From: [REDACTED]
Sent: 29 September 2026 12:45
To: Planning
Subject: Formal Objection – Proposed Surface Water Drainage Strategy, HDC DC/25/2114 + Attachment
Attachments: FLOOD PHOTOS.pdf
Categories: Comments Received

Formal Objection – Proposed Surface Water Drainage Strategy, HDC DC/25/2114

Figure 2-1

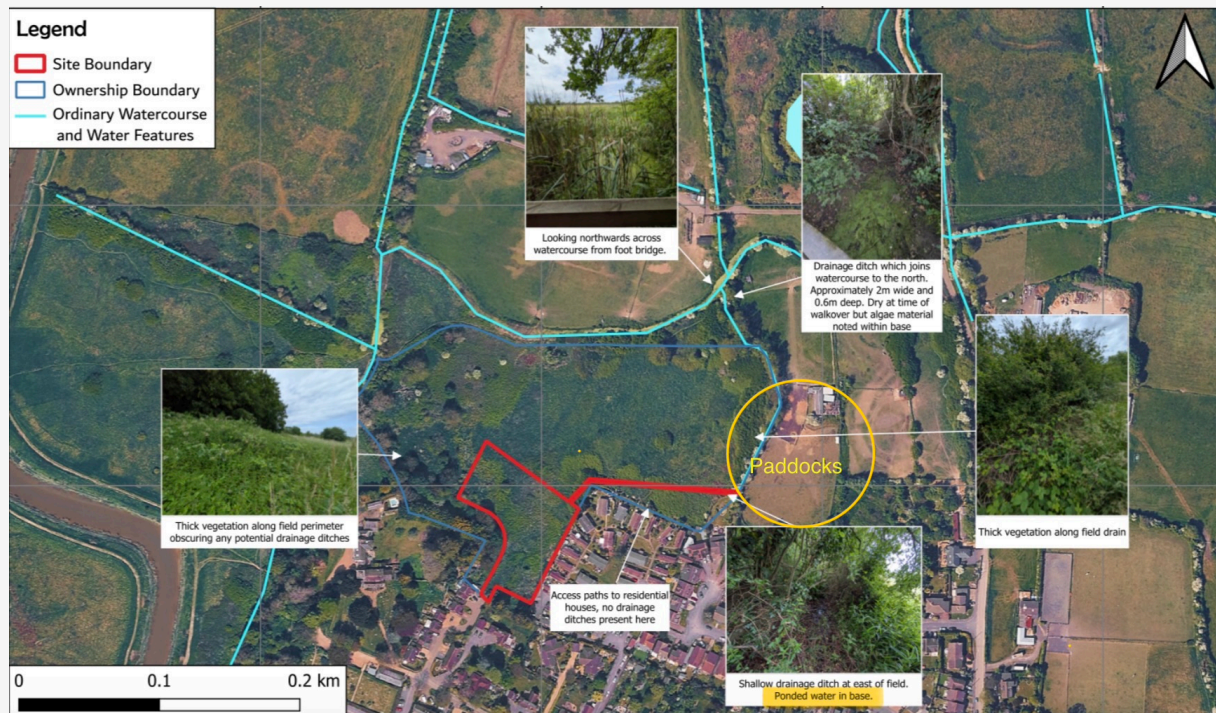
I am writing to formally object to the above planning application, specifically the proposed surface water drainage strategy and the outfall pipe shown as the red discharge line. This pipe is intended to convey water from the proposed on-site swale directly into a shallow ditch within the adjoining low-lying watercourse network.

The strategy appears to assume that the outfall will discharge freely. However, during periods of heavy winter rainfall, the receiving ditch may already contain substantial quantities of water. If the outlet becomes submerged or the receiving channel is unable to convey the additional flow, the discharge will be subject to backwater conditions rather than the assumed free outfall.

- hydraulic modelling incorporating a surcharged or submerged outfall;
- a physical assessment of the downstream ditch’s actual depth, width, gradient and conveyance capacity; or
- sufficient evidence that discharge from the pipe can be accommodated without increasing flood risk to adjoining land.
